Subject: Response to El Paso County Review
Peterson Road Subdivision
Colorado Springs, Colorado
CTL|T Project No. CS19836-115-L2

Cimarron Hills Southeast Mixed
Use Filing No. 1

Subject: Response to El Paso County and CGS Review
Preliminary Geotechnical Investigation and Geologic Hazard Evaluation
Peterson Road Subdivision, Tract C
Colorado Springs, Colorado
CTL|T Project No. CS19836-115-L1

**Surficial
Geologic
Conditions**

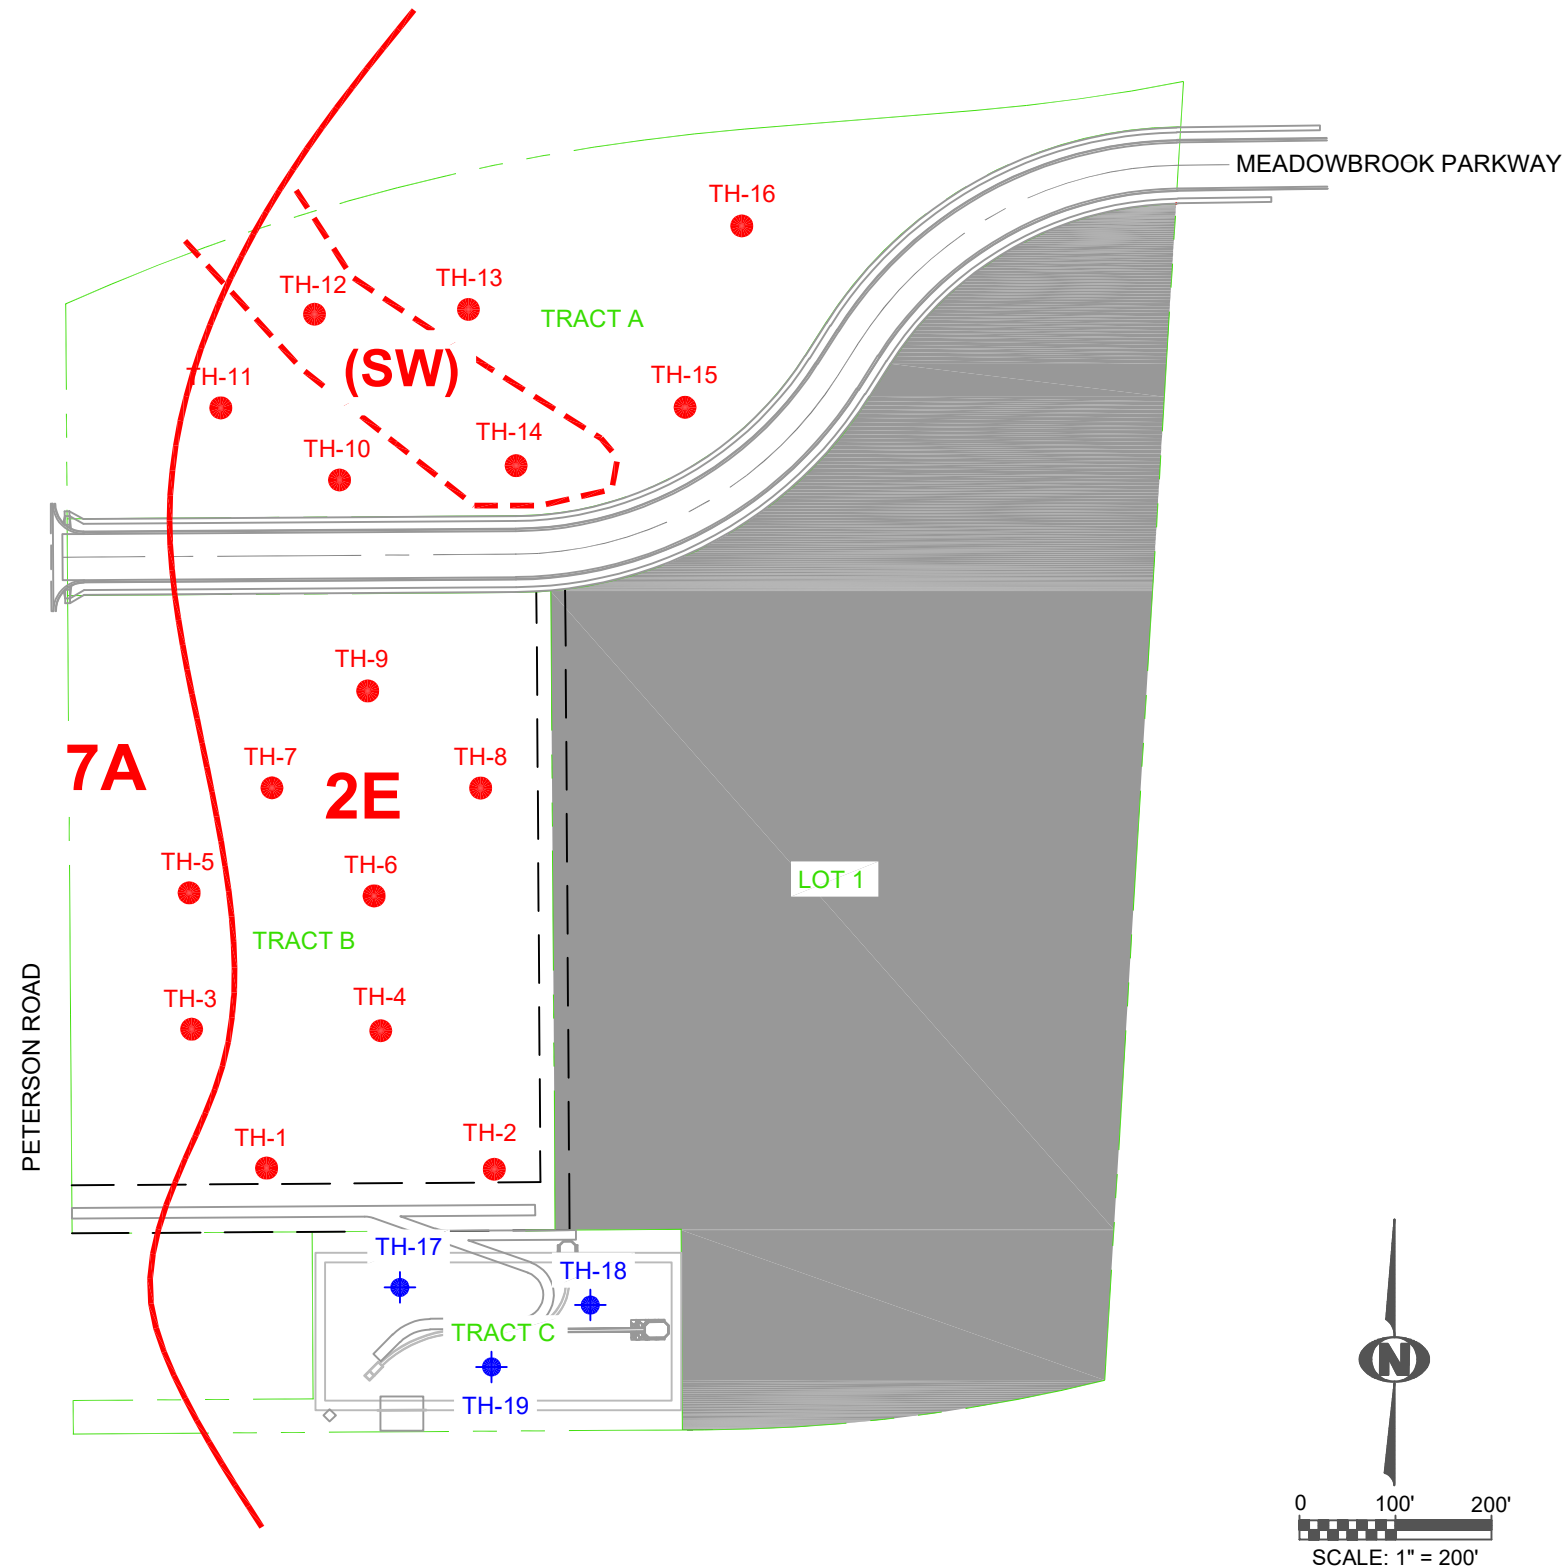
There is a review comment on the cover page of the report which states: “*this report does not include a geologic hazards/constraints map, please include this map*”. The mapping of constraints was on Fig. 3 – Engineering Conditions. This Figure has been revised to include more detail of the Robinson classifications typically used in this area to describe constraints.
